REVOLVER

FUSELAGE ALIGNMENT HOLE

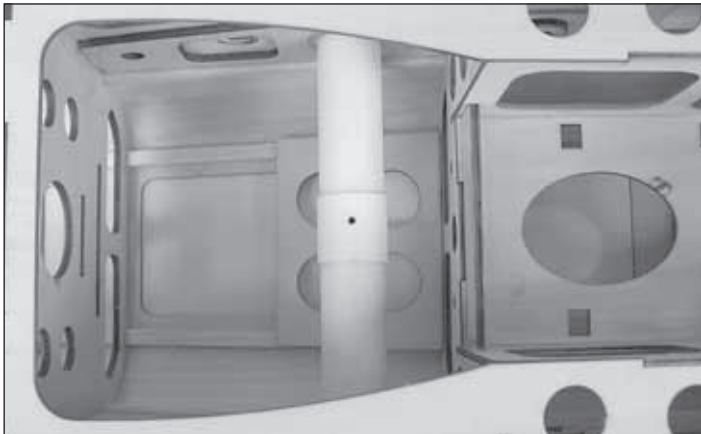
Step 1: The Fuselage alignment hole mentioned on page 11, step 3 under ***Finishing the Wing Panels*** is an optional step. The screw going into the fuse tube and then into the wing tube does not contribute to the structural integrity of the Revolver. It is intended to aid in the removal of the wing. If you choose to use the fuselage alignment hole with screw and you find that the hole is misaligned measure to the center of the tube in the fuse. Then insert and rotate the wing tube and re-drill the hole with a #44 drill bit (.086" or 2.19mm). Finally, insert the screw.
